# UNITED STATES PATENT AND TRADEMARK OFFICE

APPLICATION NO.	FILING DATE	FIRST NAMED INVENTOR	ATTORNEY DOCKET NO.	CONFIRMATION NO.
10/766,391	01/28/2004	Douglas Dombrowski	DP-311282	3331

## Office Action Summary

# **ATTACHMENT # 1**

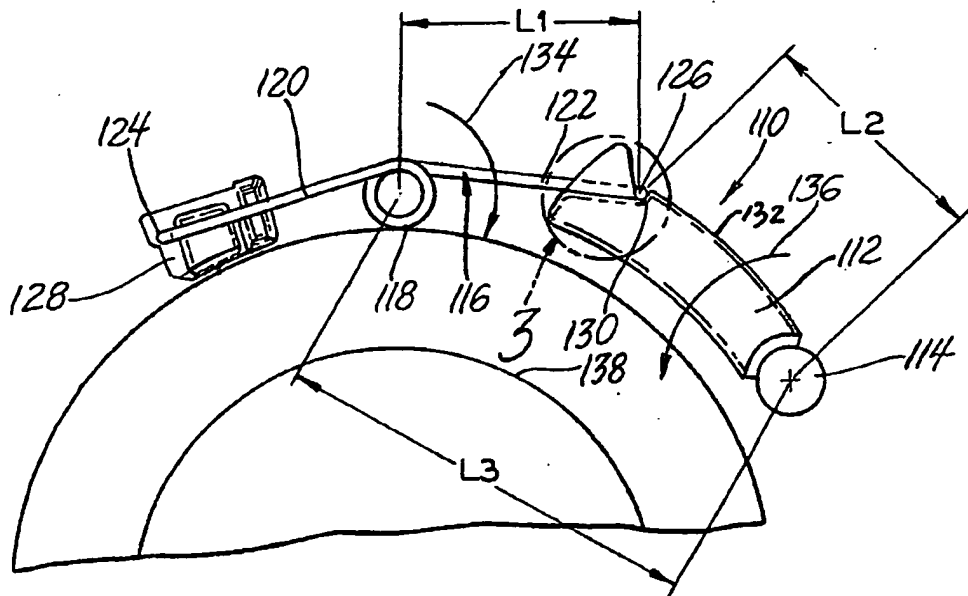
Regarding claim 2, admitted prior art teaches a two position, spring biased lever system comprising a lever 12 that pivots on a support 14 between a first (up) position and a second (down) position, and a spring 16 having a spring arm 20 that engages a notch (unnumbered. See Attachment 1) in the lever 12 to hold the lever 12 in the first position while biasing the lever 12 toward the second position when the lever 12 is in the first position.

## **ATTACHMENT # 2**

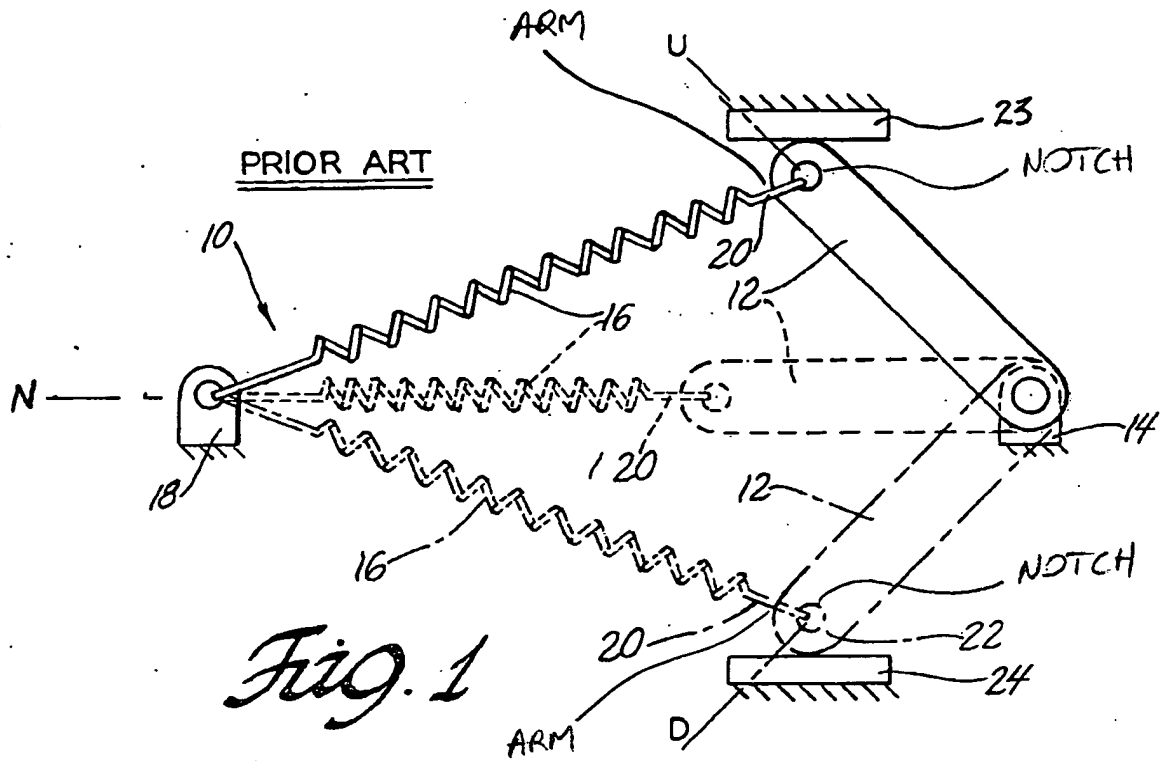
Regarding claims 6 and 7, the spring arm 34a has a length L-1 (see Attachment 2) measured from its pivot to the distal end, wherein the lever has a length L-2 (Att. 2) measured from its pivot to the notch, and wherein the system has a length L-3 (Att.) measured from the

pivot of the spring arm to the pivot of the lever and wherein the sum of the length L-1 and the length L-2 exceeds the length L-3 when the lever is in the first position as seen in Fig. 1.
